**EVALUATION OF A SELECTED SITE FOR A PROPOSED
JOPLIN WATER SUPPLY RESERVOIR ON BAYNHAM BRANCH**

PHASE 1 REPORT

December 29, 2020

**Thomas Aley, Missouri Registered Geologist 0989
Senior Hydrogeologist and President
and
David Woods, Senior Project Scientist
Ozark Underground Laboratory**

Figure 16. Comparison of an unaltered geologic section of Mississippian rocks with one affected by solution and mineralization, showing the differences in porosity. Source: Feder et al. (1969).

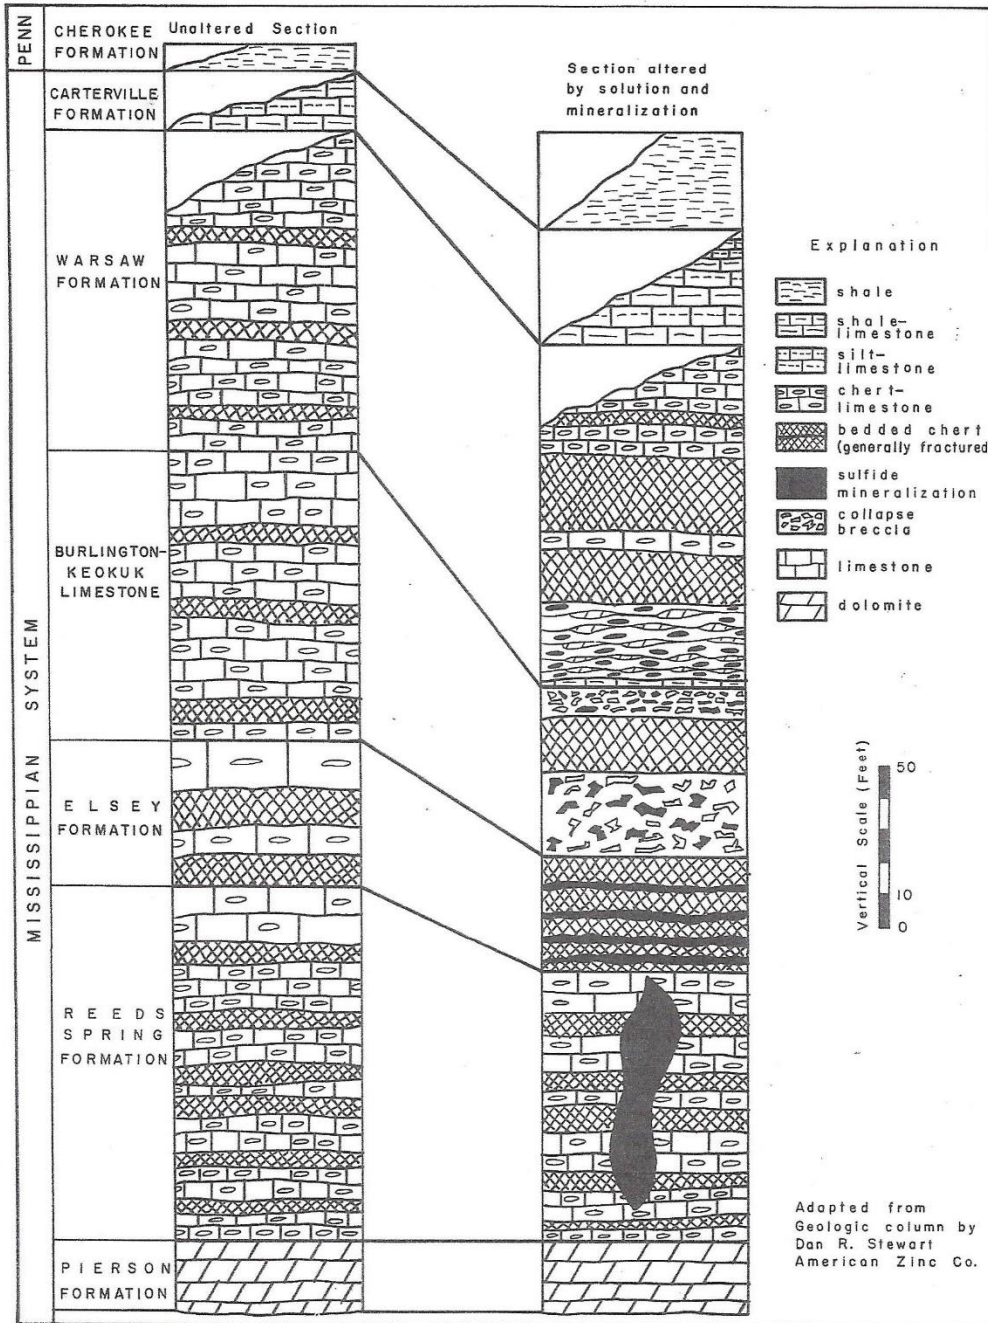
Figure 16 is a copy of figure 4 in Feder et al. (1969); that report was a study of the water resources of the Joplin area. The figure provides a comparison of an unaltered geologic section of Mississippian rocks with one affected by solution and mineralization and shows difference in porosity. It also shows the extent to which the thickness of various geologic units in the area has been reduced due to solution and collapse. As shown in the illustration the Burlington-Keokuk Limestone has been reduced to only 59% of its initial thickness due to these processes. While the degree of formation thinning varies from point to point, it is a regional condition and must be expected in and around the dam site. Within the vicinity of the impoundment solutional activity, interactions between mineral deposits and bedrock, and fracturing would have increased the permeability of the rock units and should be expected to have done so to substantial depths below the ground surface.

Decreases in the thickness of the Burlington-Keokuk is important in evaluating the risk of failures of dams to minimize subsurface leakage and resulting sinkhole collapse. Localized dissolution of limestone resulted in subsurface collapses and subsequent mineralization in the collapse zones and produced breccia deposits that are substantially more permeable than the unaltered rock. These processes also increased fracturing of overlying rock units. Where these processes have operated, they increase the risk of subsurface leakage from impoundments and resulting land subsidence or sinkhole collapse.
